STAFF REPORT: 06/12/2024 REGULAR MEETING

APPLICATION NUMBER: HDC2024-00260

ADDRESS: 553 ARDEN PARK

SCOPE: REPLACE REAR PORCH WITH DECK, PERGOLA, AND GAZEBO, INSTALL FENCE AND SECURITY CAMERAS (WORK COMPLETED WITHOUT APPROVAL)

Site Photo 3, by Staff May 28, 2024: (Northeast) side and rear elevation, showing rear extension with enclosed windows at second floor. Also showing erected gazebo and deck (work completed without approval). Red dashed lines added for clarity.

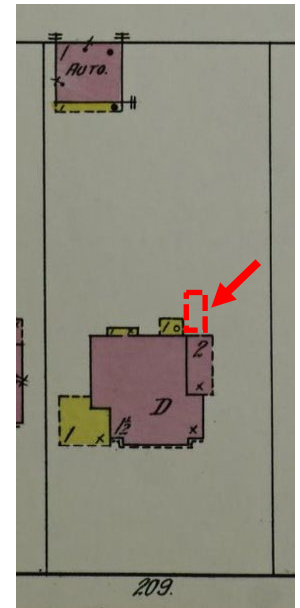
- Pictured to the right (*site photo 3, Figures 2-3*), the rear extension was permitted for construction in 1924, as shown in city files, 10 years after the house was initially constructed, also shown in building permit cards and sanborn maps. Staff was not able to determine when the upper windows of this rear extension were filled in. The applicant has noted that this work was completed prior to his moving in the house in 1970, which is also before designation. This work is not in the application.

- Staff received a description from the applicant that the purpose of the deck was offset storm drainage into the cellar below, which is located next to the rear porch (See site photos 2-3.) The applicant also provided narrative on the purpose of the proposed arbor for the same purpose; basement flooding and dampness has been an issue and the applicant is attempting to offset this condition.

Site Photo 4, by Applicant, May 2024: (North) rear elevation, showing deck, arbor and gazebo and contrasting rooflines with the house.

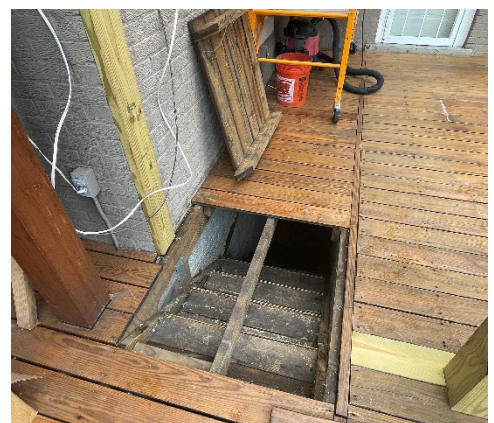
- It is staff's opinion that the removal of this porch and covering the original porch deck with a new deck, arbor and gazebo is inappropriate. The original porch's simple roofline, porch post detailing, which matched the post at the front of the house, are characteristic of the Arts and Crafts architecture of the property. The simplicity of the form, scale and the detailing of the post, and then the removal of all these elements, reduces the form and greatly alters the porch's distinctive, historic expression. (See photo 2 and 4)

- construction detailing of the arbor and gazebo shows the elements being joined together (see site photo 6),
 - the introduction of the lampposts adds additional features that are not appropriate to the architecture nor appropriately placed on a wood deck structure. (See site photo 4)
